DUKE POWER COMPANY

OCONEE NUCLEAR STATION

TECHNICAL SPECIFICATIONS

TECHNICAL JUSTIFICATION

FIGURE 4 - PARTIAL SITE PLAN

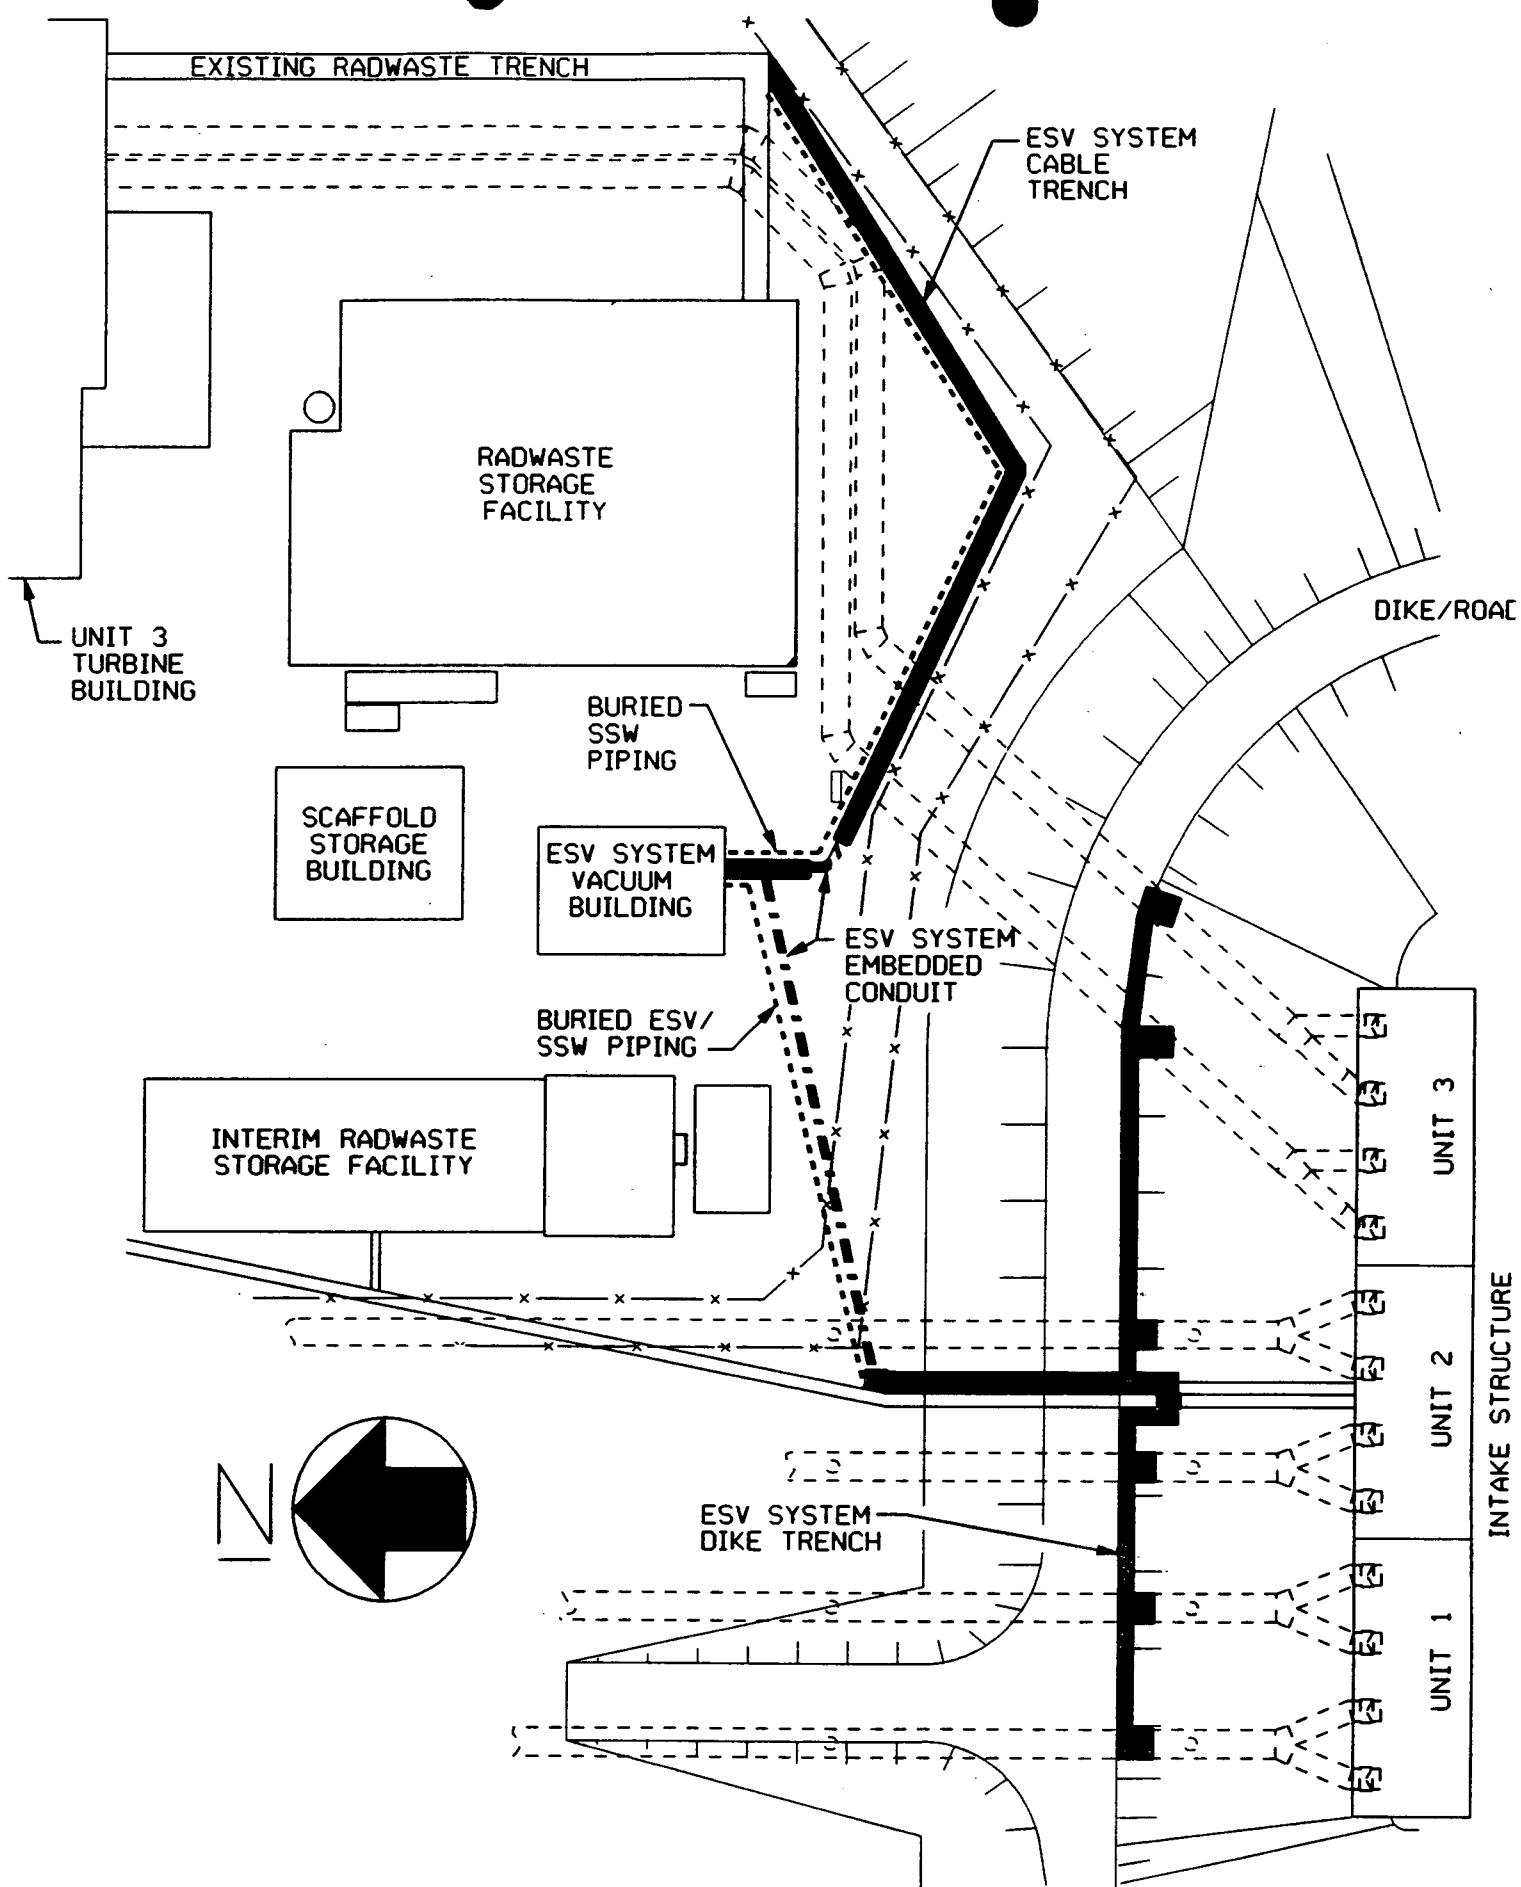
The ESV System vacuum pumps and tanks are supported by a seismically qualified, QA-1 reinforced concrete foundation located in the plant yard just north of the CCW intake dike (Figure 4). A seismically qualified, QA-4 pre-engineered structural steel building provides shelter for the ESV System vacuum pumps and other components. All QA-1 equipment is supported by the reinforced concrete foundation. The heating and ventilating system for the building is non-QA because it is not required to support ESV System operation.
